Remarks

Response to Drawing Objection

Response to Claim Rejection Under 35 USC §102

# APPENPIX A (page 1 of 2)

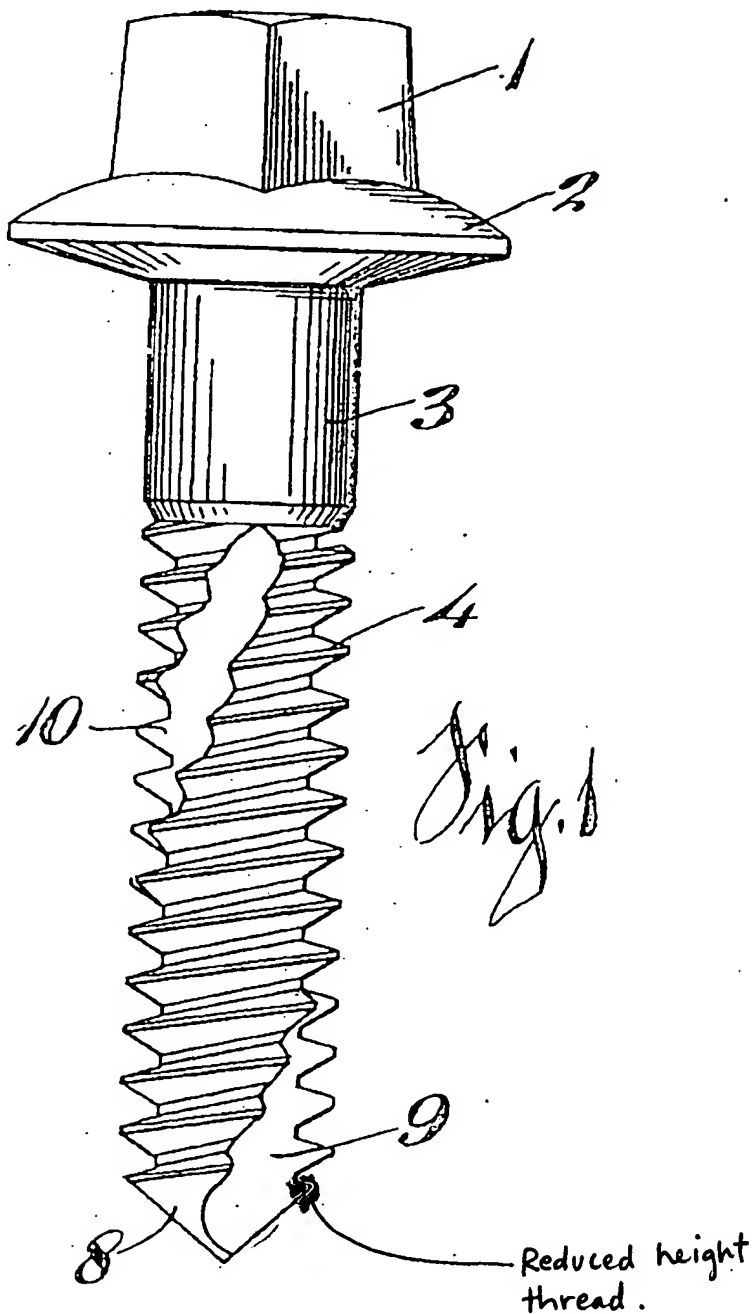
Holmes et al. fail to disclose a screw with a thread having a uniform height. As shown in Figs. 1 and 2, the height of the thread (4) at a location closest to the tip (8) of the screw is less than the height of the thread at other locations, and therefore the height of the thread is non-uniform. Enlarged  
\* copies of Figs. 1 and 2 are attached hereto as Appendix A. The reduced height thread is shaded red. Holmes et al. do not disclose or suggest that the thread may have a uniform height.
